Illabo to Stockinbingal (I2S) EIS - Submission

We are Carl and Nicole Baldry, the owners of [REDACTED]. We have lived here since 2017, with our young family, and have been in the area since 1994. We purchased the property before being made aware of the proposed construction of a greenfield section of rail between Illabo and Stockinbingal, and connection to the existing rail network at Illabo and Stockinbingal, to accommodate the requirements of Inland Rail ('the proposal'). We object to the proposal ARTC Inland Rail on a number of grounds including:

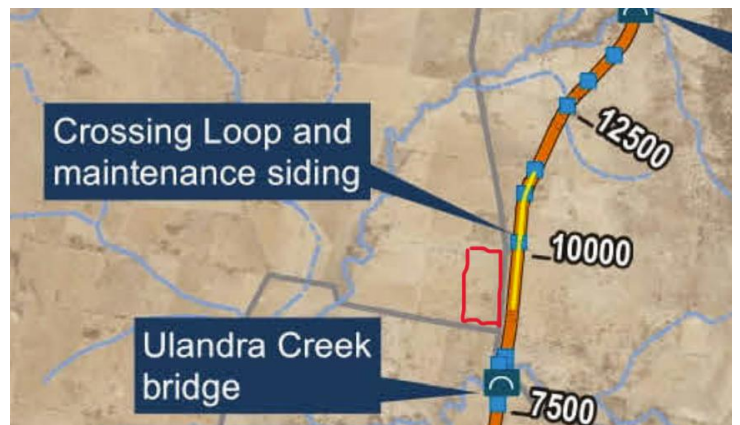
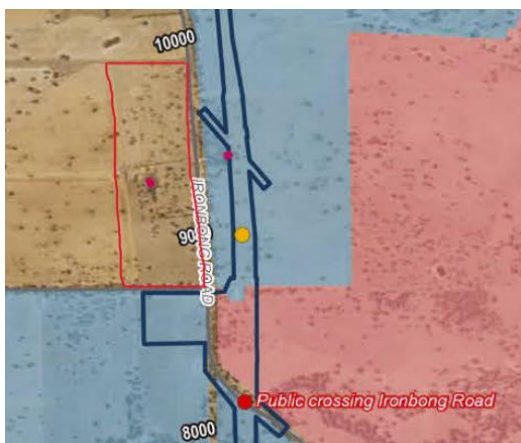
Our property is 100 acres and runs parallel to the proposal. The front door of our house will be approximately 400m from the line and within 200m of our property's boundary fence. Our farm runs about 30 stud Simmental breeding females and their calves, which are produced for the beef cattle seed stock industry. We have our annual on-farm cattle sale at our family's farm about 25 kilometres from our property. Below are some images from the EIS and ARTC Inland Rails website showing our property location in relation to the proposal. The four images below indicate our property within the red rectangle.

Considering the proximity of our house and property to the proposal, we cannot understand how the location is justified. How was the location of our house considered in the identification of the alignment? We appear to be among the many grossly affected properties by the greenfield section of rail (which is not being acquired) by virtue of the location of the following aspects of the proposal:
